Addendum No. 1

Re: **Playground Equipment – Monarch Elementary School**

IFB No.: **424-19-9-14**

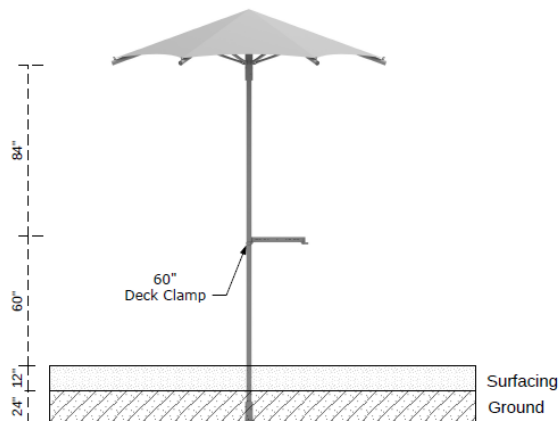
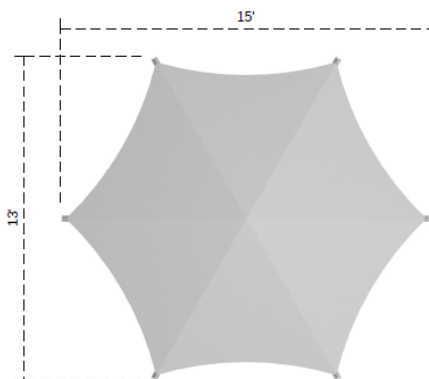
3.)GCSD has not required engineered stamped drawings for shades that re incorporated into a structure such as the 3.5" hex shade for the upper deck of existing play structure. In fact, I am not sure that it would be possible to obtain. Is the engineered stamp drawing s a requirement for this shade?

Only the cantilever t-shade structure requires stamped engineered drawings. This is not required for the 3.5" hex shade. (Drawing of shade is attached to this document).
